PORTION OF SE QUARTER OF SEC 27, TWN 20 N, RGE. 4 E, W.M.
CITY OF PUYALLUP, PIERCE COUNTY, WASHINGTON

SITE PLAN

FORTRESS - PUYALLUP

Job Number
22085
Sheet
C4 of 34

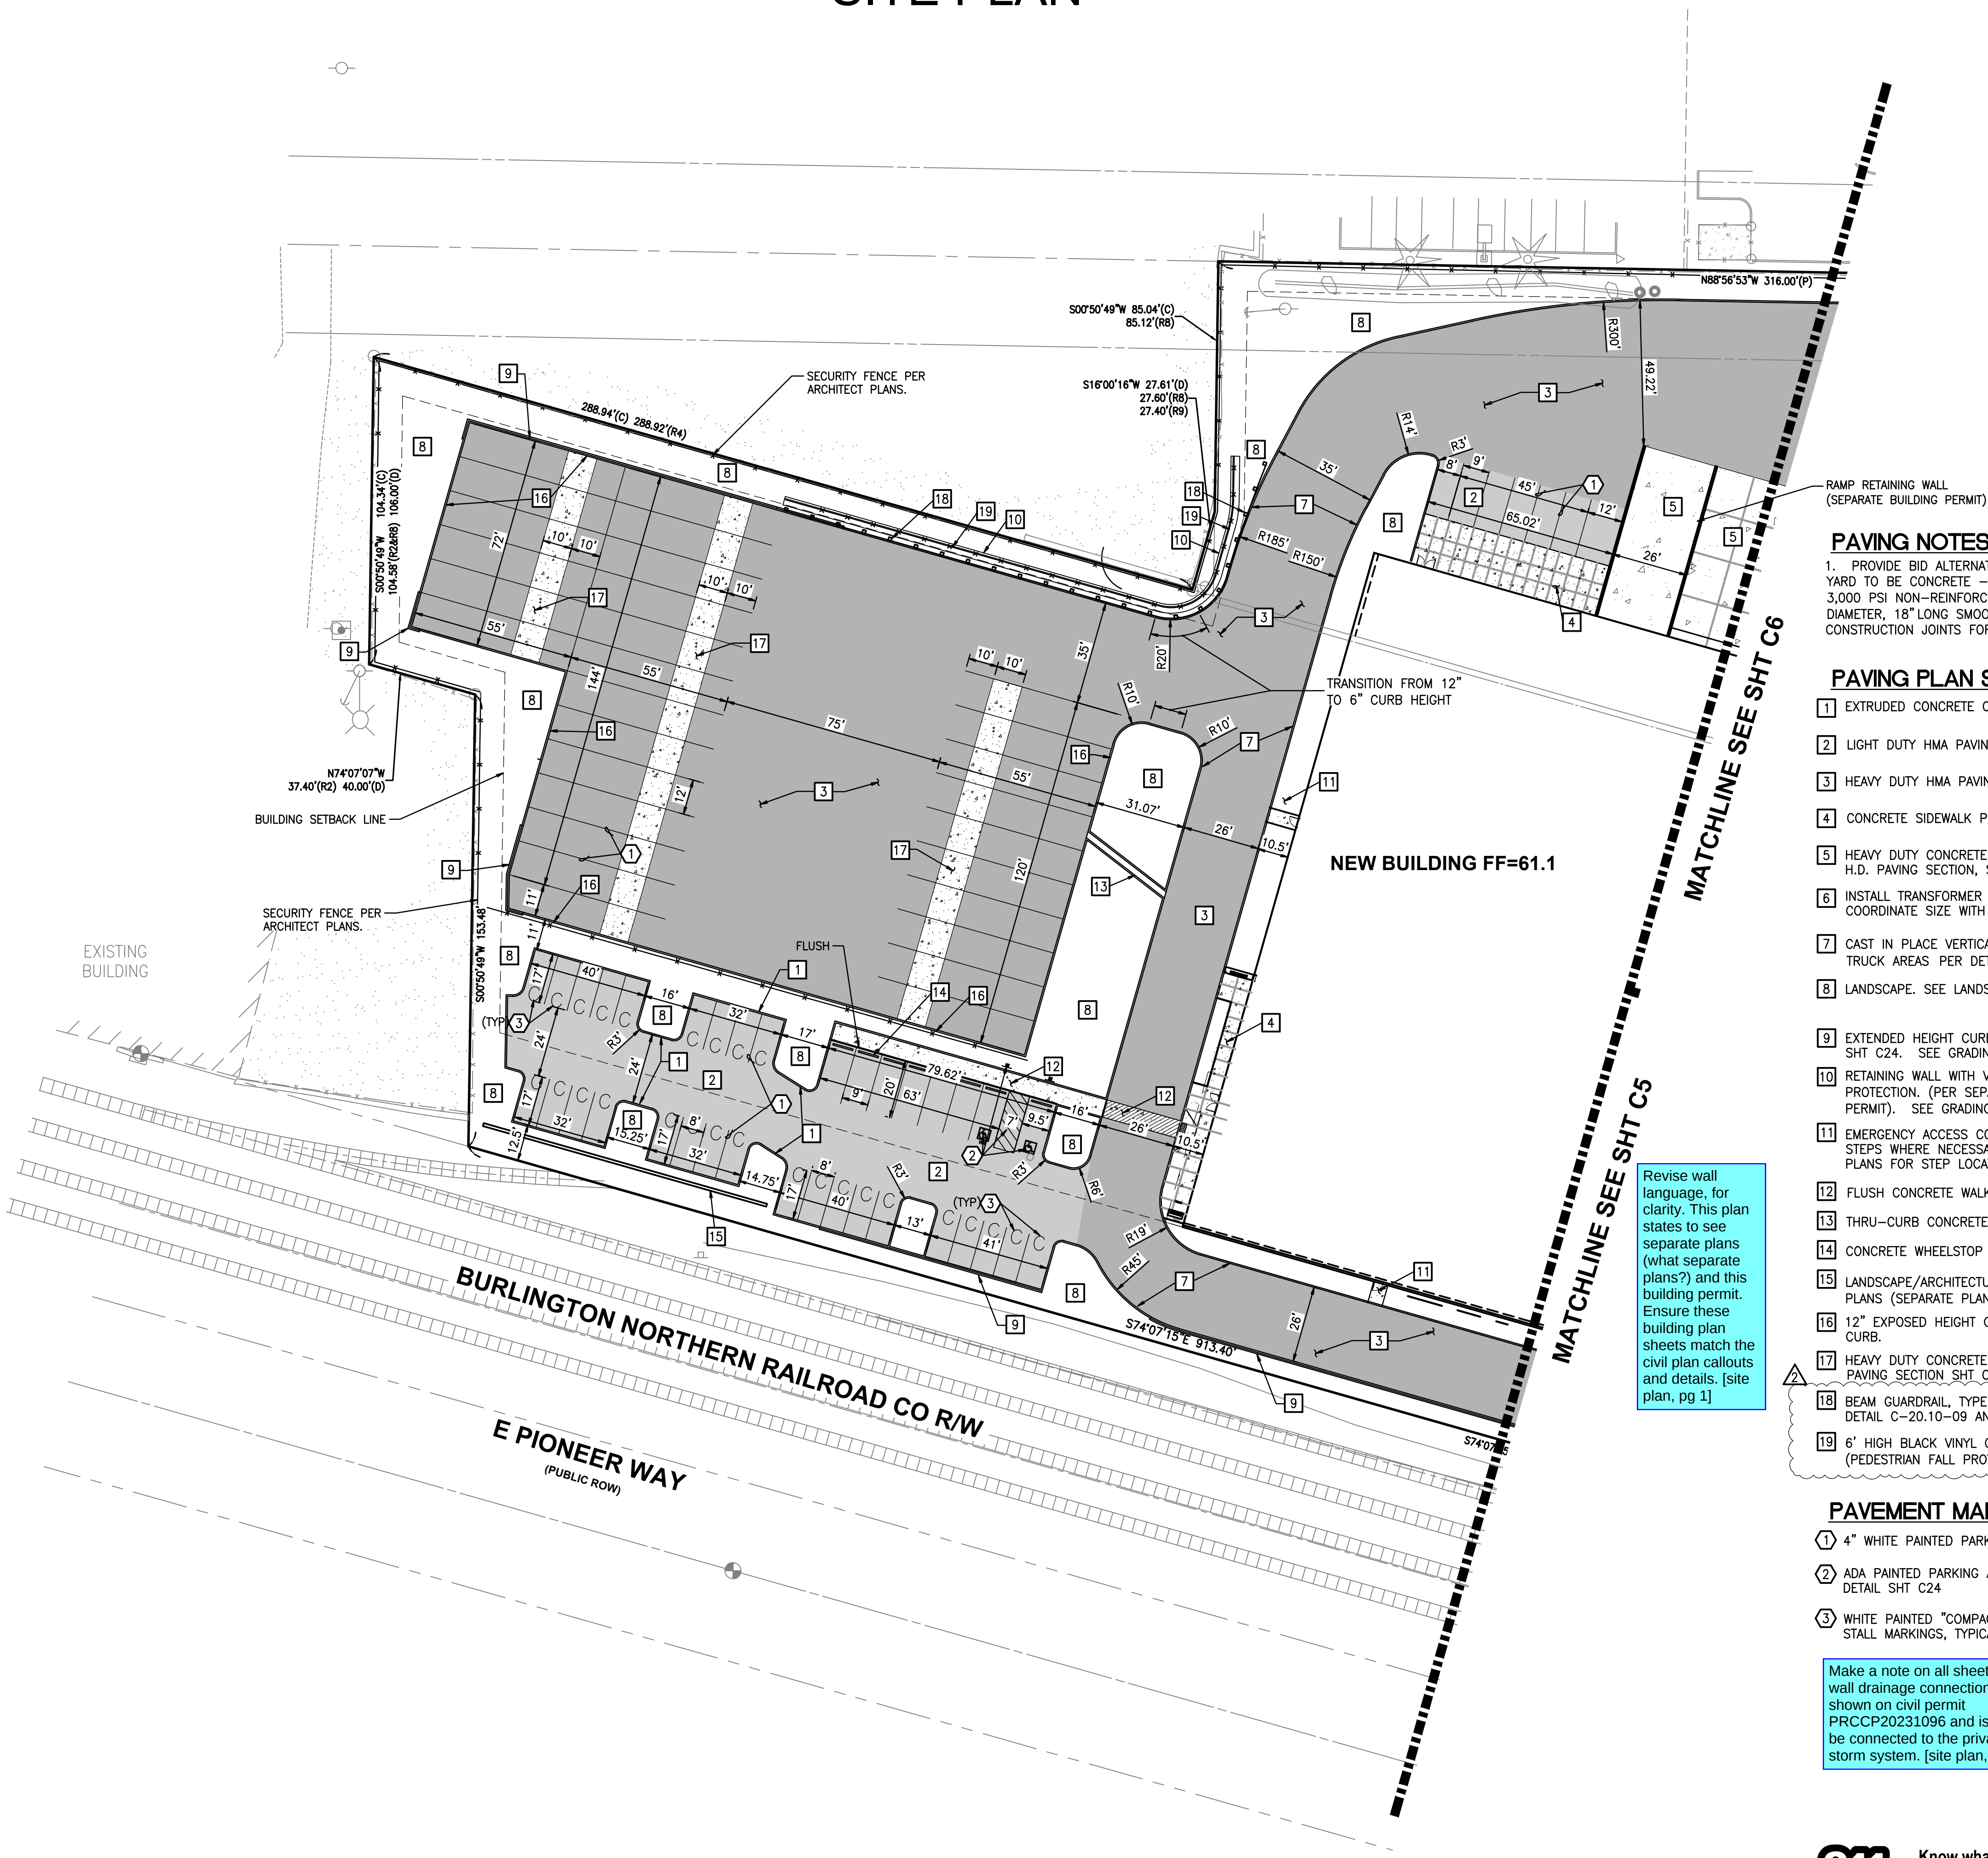
Make a note on all sheets that wall drainage connections are shown on civil permit PRCCP20231096 and is to be connected to the private storm system. [site plan, pg 1]

Revise wall language, for clarity. This plan states to see separate plans (what separate plans?) and this building permit. Ensure these building plan sheets match the civil plan callouts and details. [site plan, pg 1]

Steps shall be taken to prevent drainage onto adjacent lots and below and beyond the toe of the wall.

Job Number	22085	Sheet	C5	34
------------	-------	-------	----	----

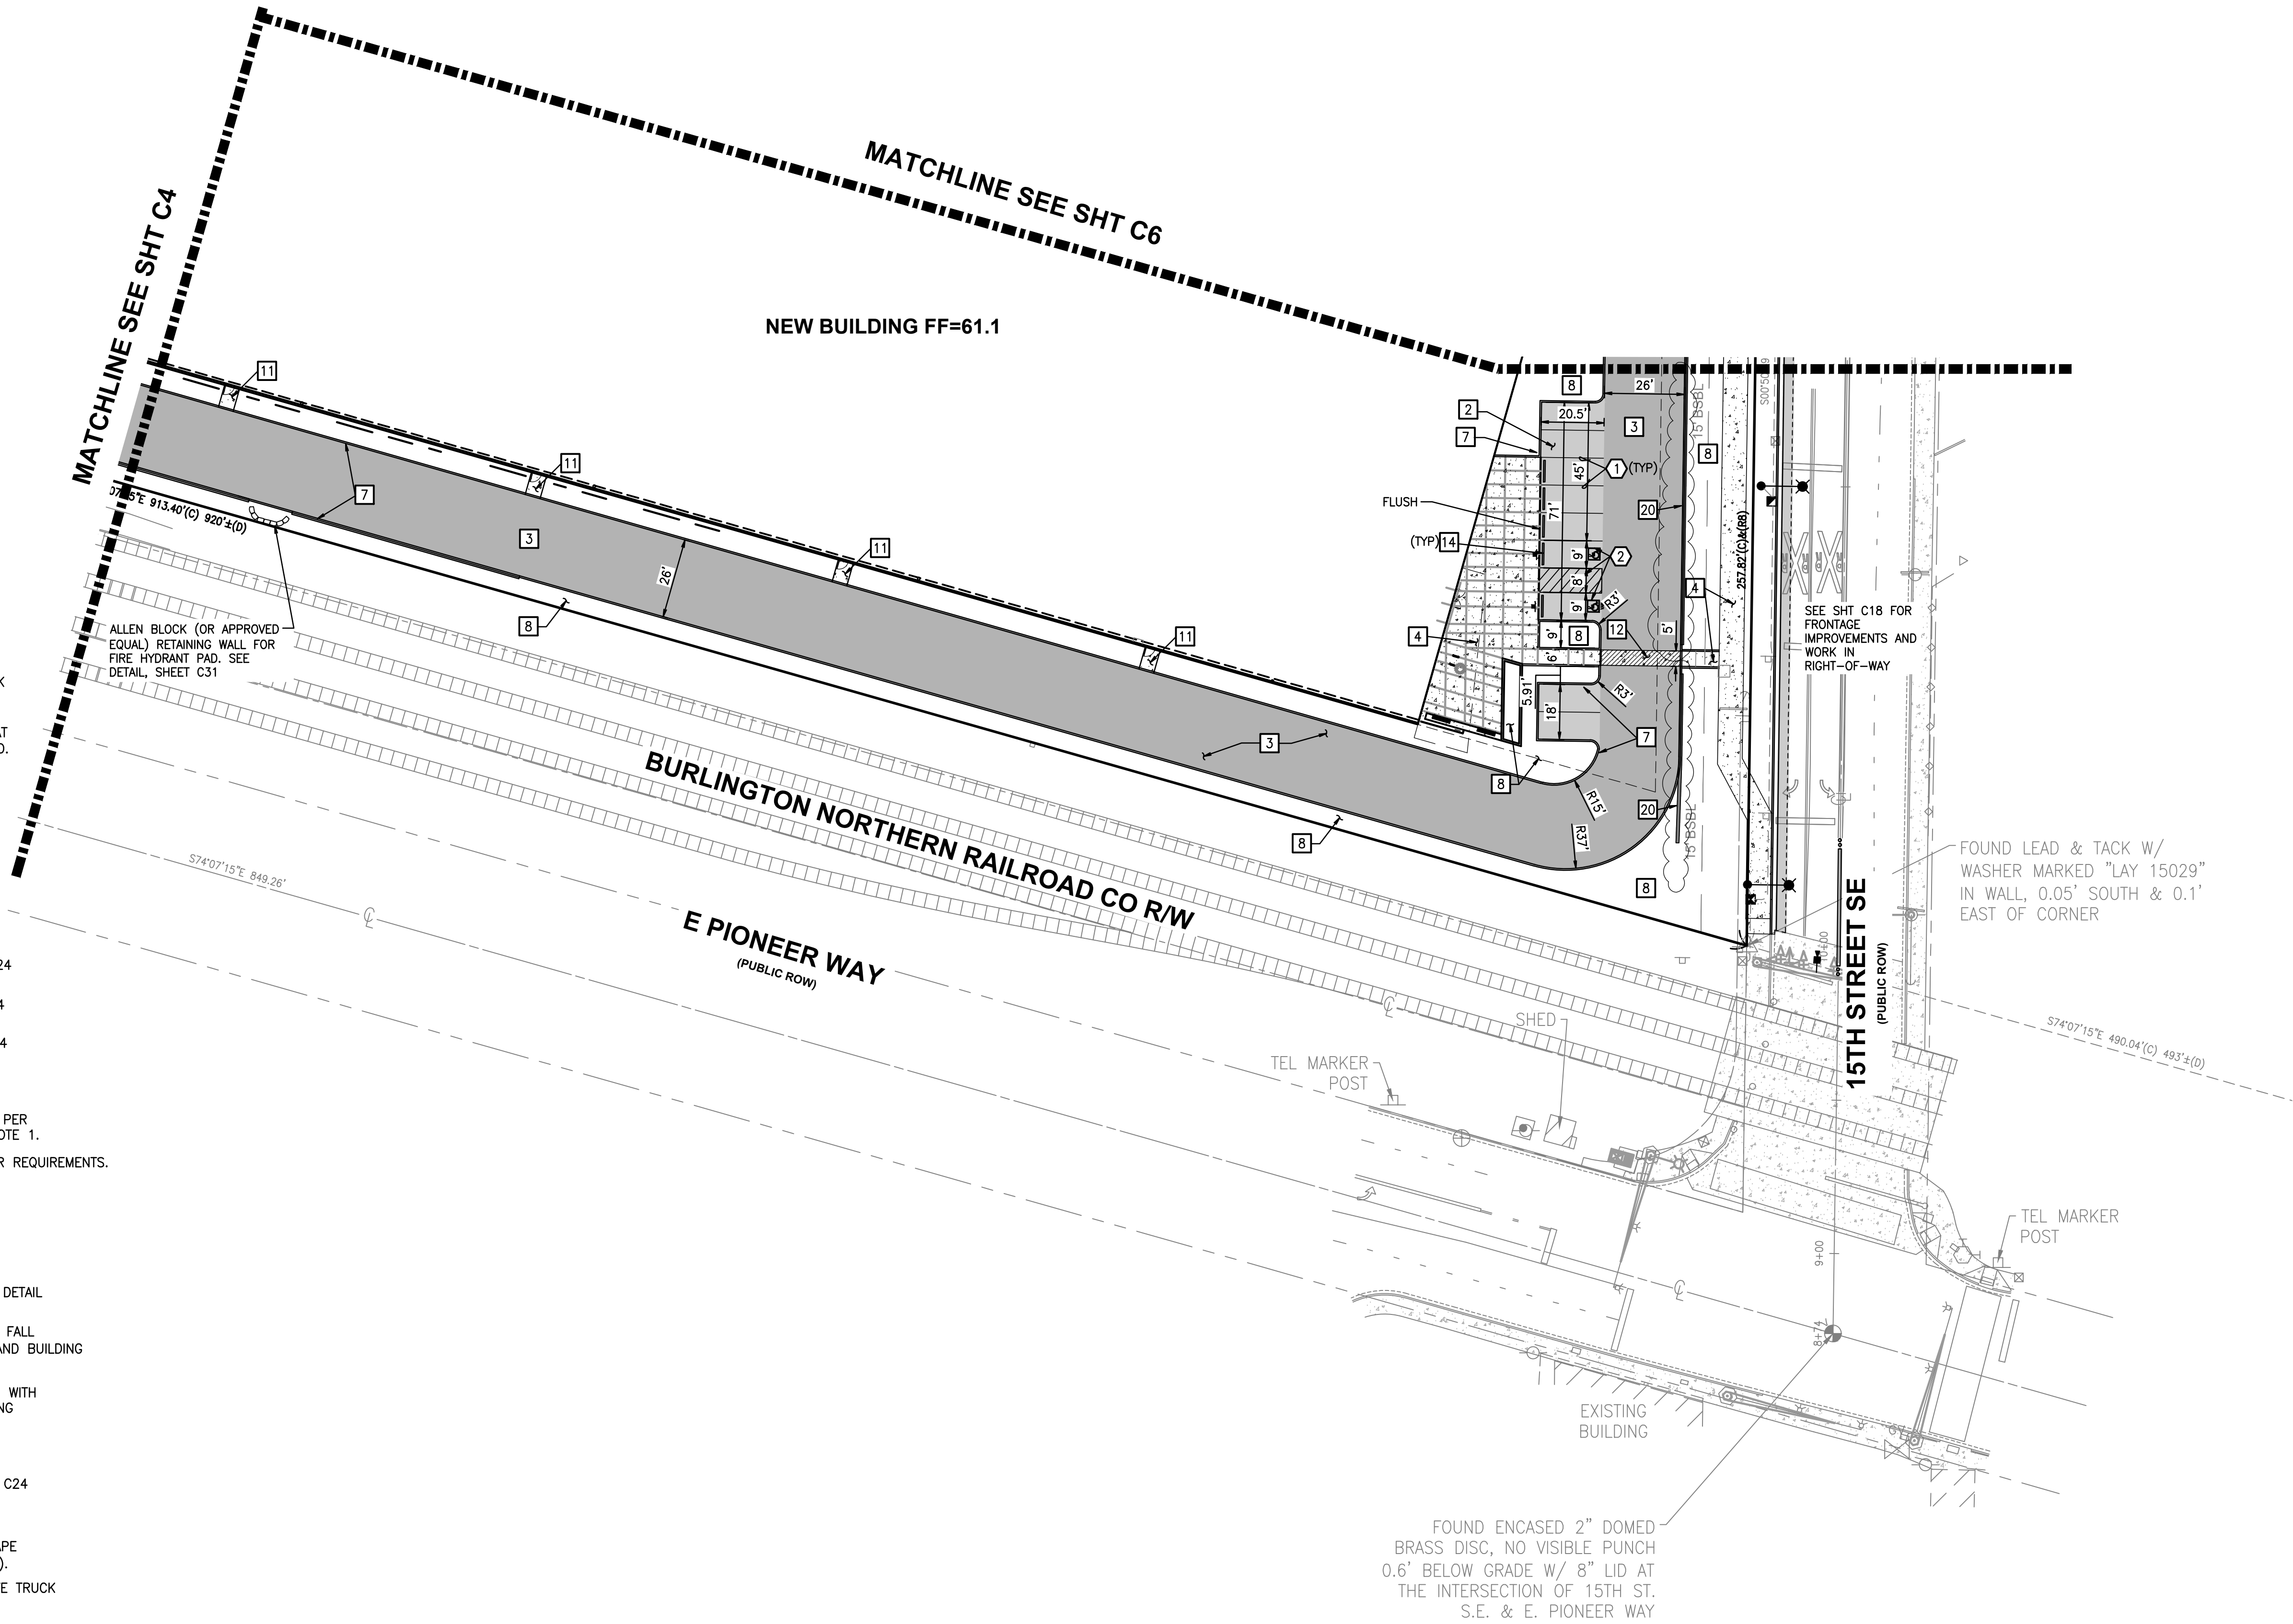
The City does not review, approve, authorize, or permit work in the BNSF Railway right-of-way. The applicant and permit holder are responsible to obtain the necessary permits from the jurisdictional agencies to complete this work. A BNSF Railway Company Pipeline or Wire Line permit may be required. The applicant or permit holder shall present a copy of the BNSF permit upon request of the City Inspector.
